**RESPONSES TO COMMENTS ON A PRELIMINARY CEQA REVIEW
PREPARED FOR A HOME DEPOT, SUNLAND, CALIFORNIA**

Home Depot Project
8040 Foothill Boulevard and 10355 Woodward Avenue
Los Angeles, California, 91040

August 28, 2008

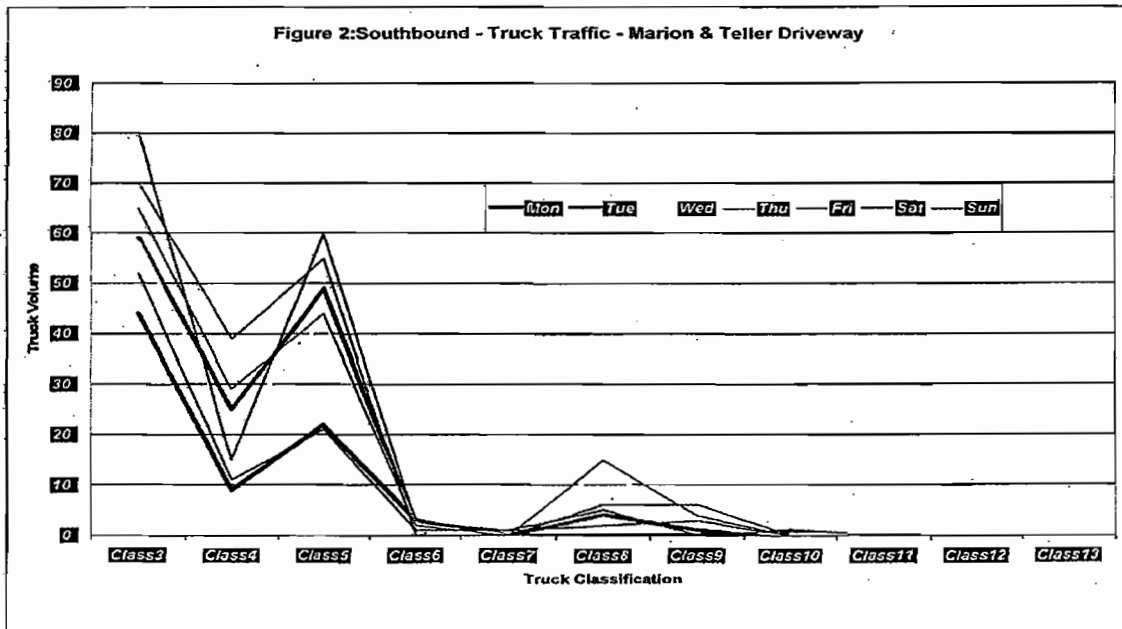
The average length of stay ranges from 20-60 minutes for each truck depending on the type of truck. Also based on length of stay on-site, these trucks contribute to noise and air pollution on site due to idling. Figure 1 shows the northbound truck traffic entering the driveway located on Marion and Teller Drive leading to Home Depot and other facilities in Newbury Park. From Figure 1 it is evident that the number of trucks coming to Home Depot and other facilities are less on Saturday, Sunday and Monday, whereas the numbers of trucks coming to the facilities are higher during Tuesday, Wednesday, Thursday and Friday. Based on this evidence the OTC report should take proper truck volume data, and one that is consistent with the sales projections in its economic analysis, in order to estimate a more realistic average truck traffic to Home Depot. It is a common practice for Home Depot prepared and submitted EIR's to indicate only 18-25 trucks per day. Some of the Home Depot sites indicate an average more than 25 truck trips per day.

not trucks, for the purpose of a traffic analysis. In addition, it should be noted that the size of the Sunland Home Depot is much smaller than the average Home Depot store constructed in the Los Angeles Area, indicating that the unsubstantiated and unverified data from a Home Depot in Newbury Park is misleading. It should be noted that the truck volume shown in the Table B page 10 do not match the truck volume plotted in Figures 1 and 2 page 10. Please also see Response to Comment 28.

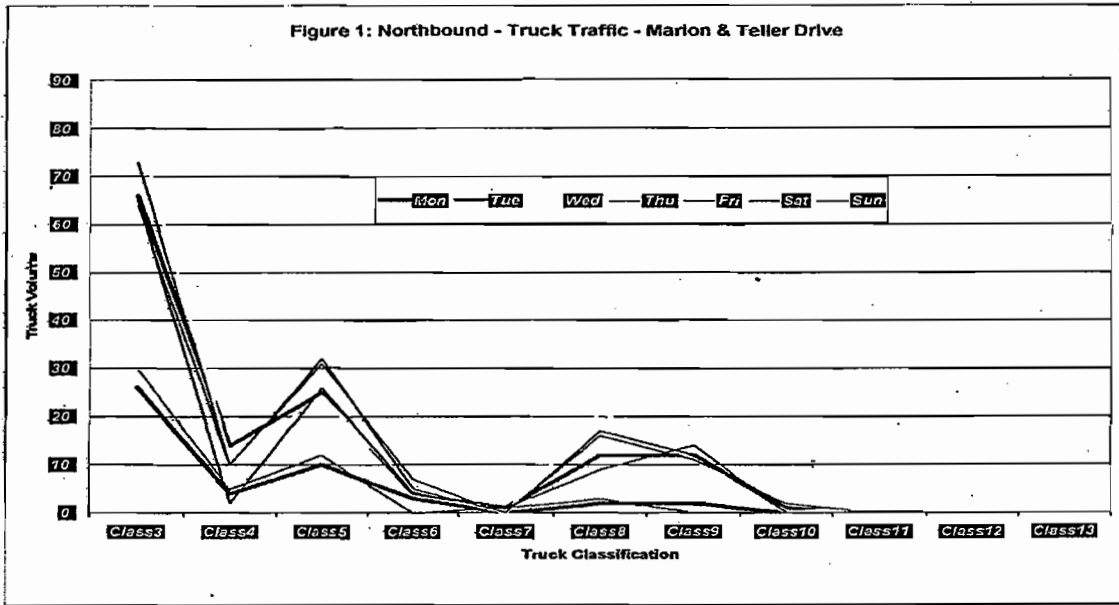
Figure 2 shows the southbound truck traffic exiting the Home Depot in Newbury Park. The question to be asked is; do the trucks leave the facilities in the same way they came in? The answer is definitely a "NO" from Figure 2. The truck drivers who deliver 2832 Alderberry Ct.

The project applicants will assure in their reports that the trucks will follow designated routes, which is not true in the majority of the cases as shown by Figure 2. Such undesignated usage of truck routes will cause additional impact on pedestrian traffic, air pollution, safety, noise pollution and community quality of life.
